PROPERTY OWNER:  
 CITY OF PUYALLUP

SITE ADDRESS:  
 115 2ND STREET SE  
 PUYALLUP, WA 98372

**1 SITE PLAN**  
 SCALE = 1" = 20'-0"

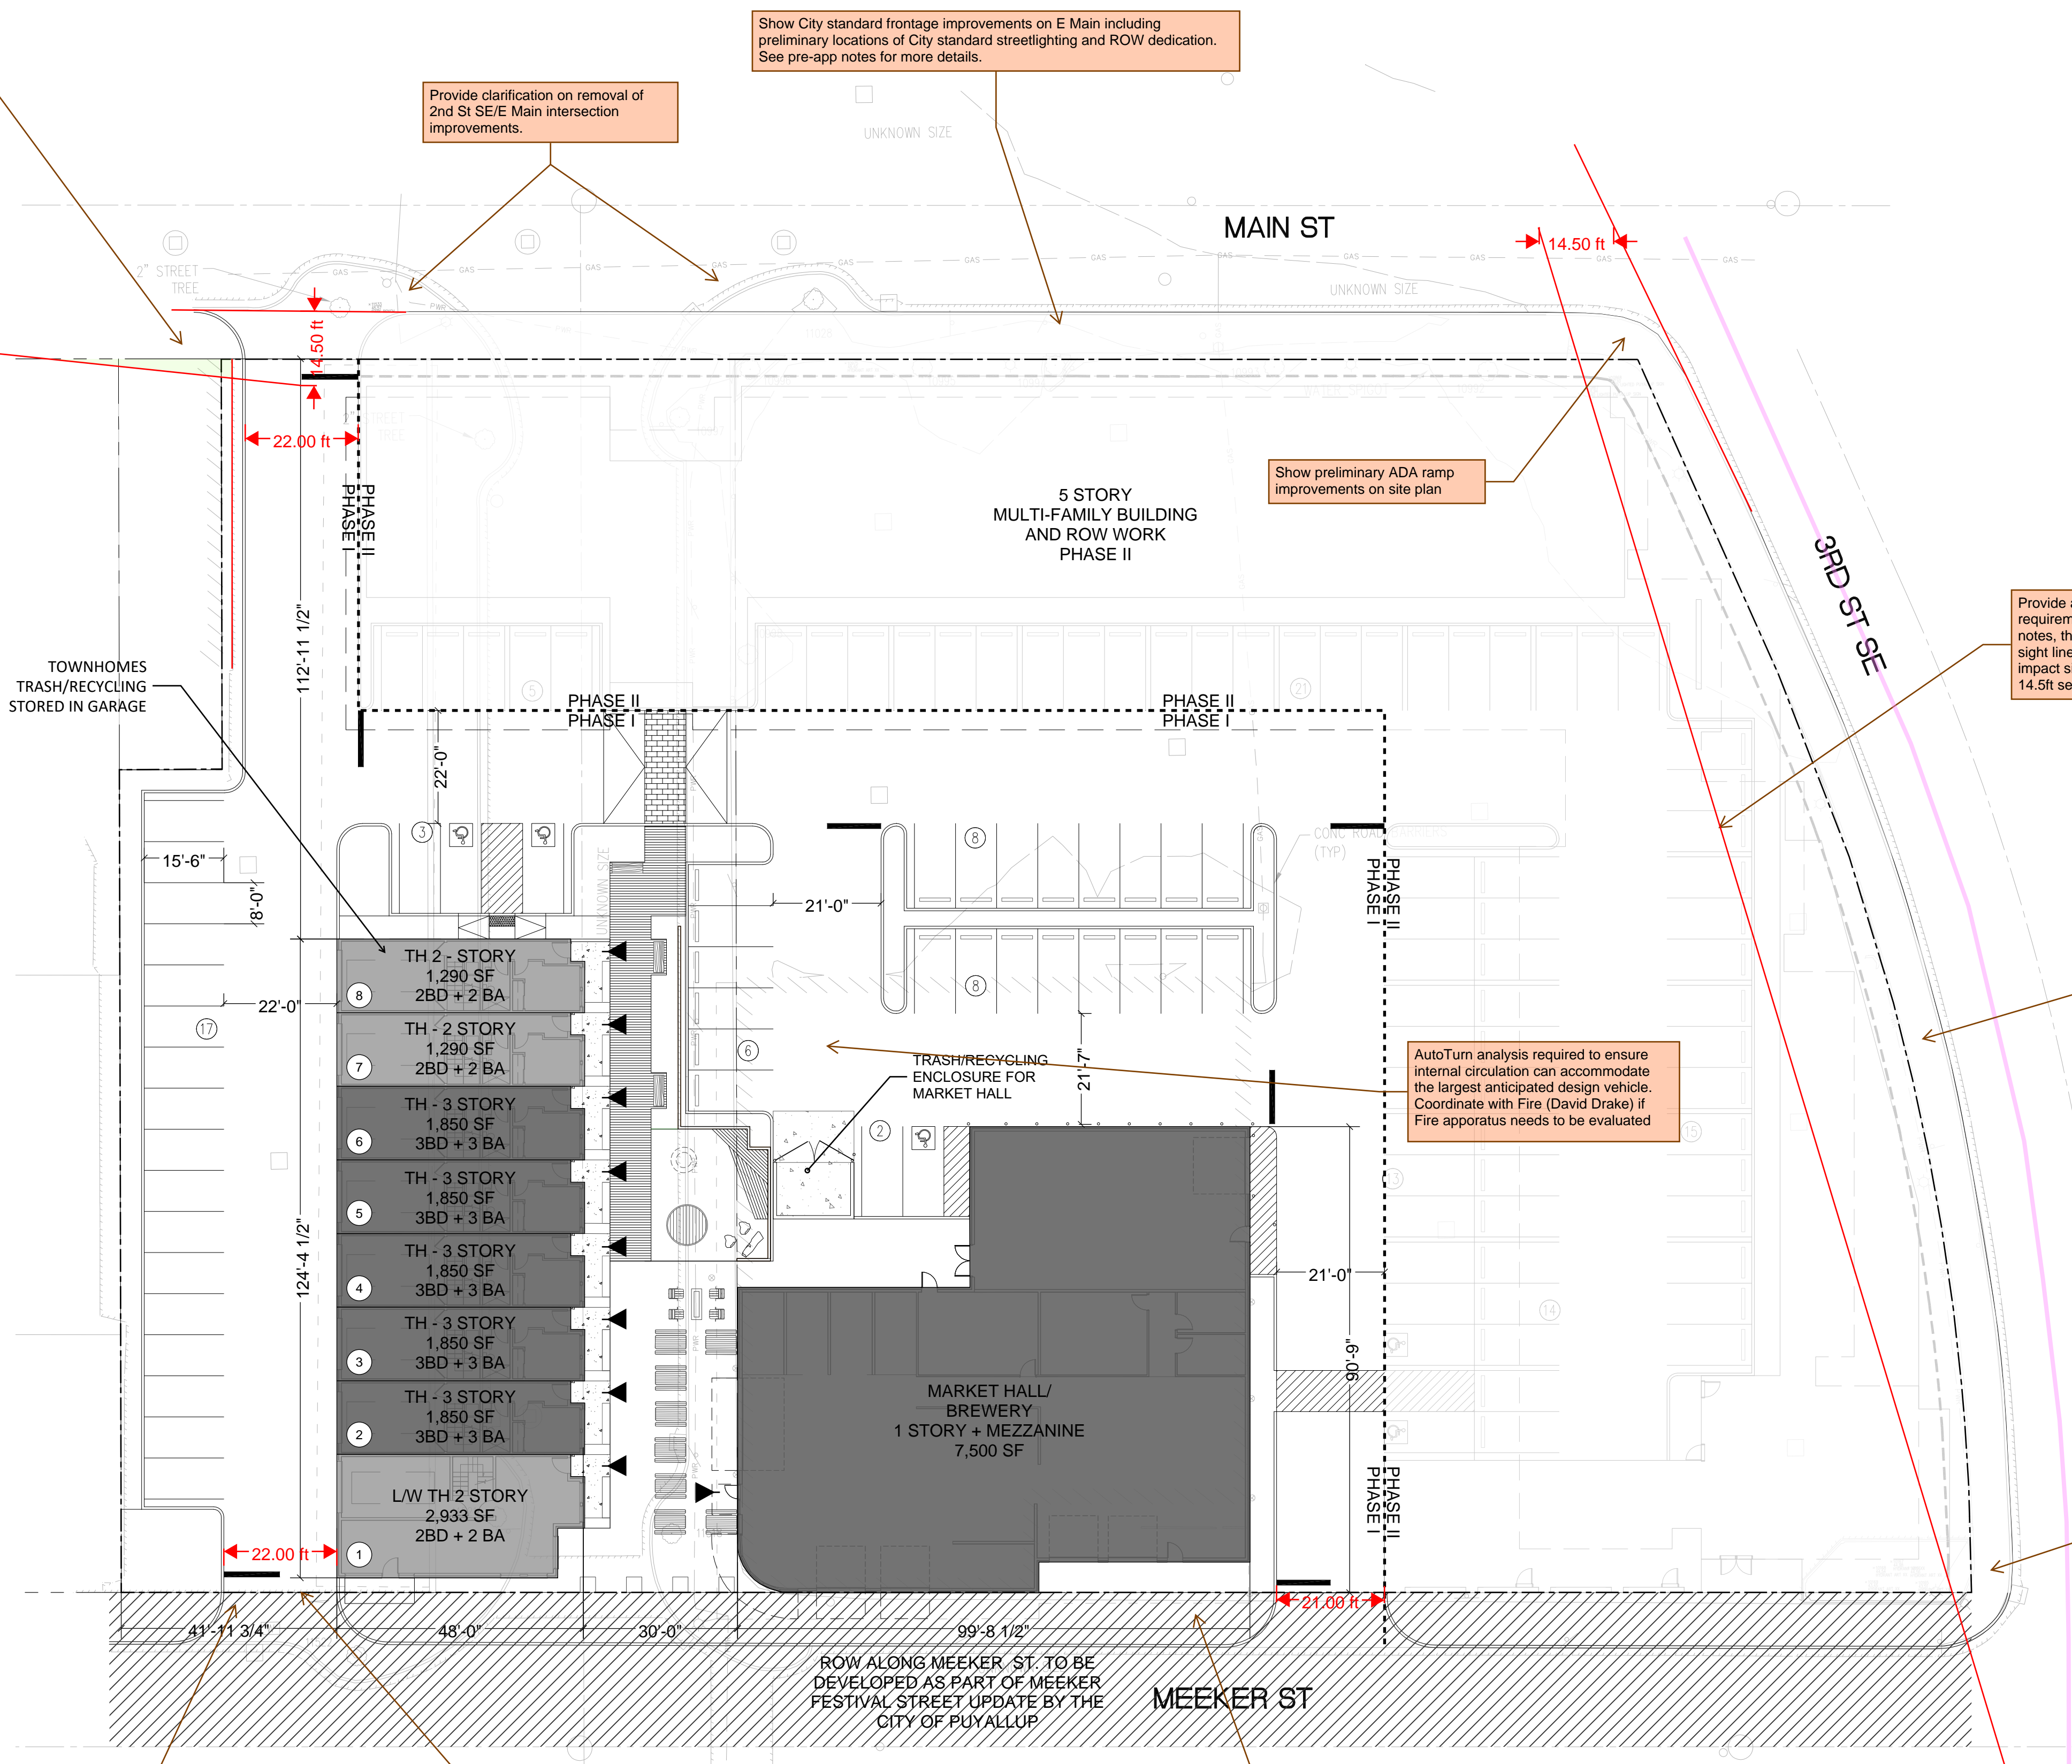
New driveway location appears to have a sight distance obstruction from adjacent building. Bulb-outs may be necessary to allow the ESD setback to be pulled closer to the edge of road.

Provide clarification on removal of 2nd St SE/E Main intersection improvements.

Show City standard frontage improvements on E Main including preliminary locations of City standard streetlighting and ROW dedication. See pre-app notes for more details.

Show preliminary ADA ramp improvements on site plan

Provide a separate sight distance exhibit to verify entering sight distance requirement are met at this intersection. Consistent with pre-application notes, the proposed building placement obstructs sight distance. Provide sight line on this site plan to ensure future building placement does not impact sight distance. Preliminary entering sight distance triangle provided. 14.5ft setback from face of curb, 350ft.

Show City standard frontage improvements on 3rd St SE including preliminary locations of City standard streetlighting and ROW dedication. See pre-app notes for more details.

AutoTurn analysis required to ensure internal circulation can accommodate the largest anticipated design vehicle. Coordinate with Fire (David Drake) if Fire apparatus needs to be evaluated

Show preliminary ADA ramp improvements on site plan

Provide a separate sight distance exhibit to verify entering sight distance requirement are met at this new driveway. 14.5ft setback from gutter, 300ft.

Commercial driveways do not meet minimum 30ft width requirements. Consistent with pre-app notes, an alternate methods request may be required

Along Meeker, show preliminary design of frontage improvements to be constructed by the City
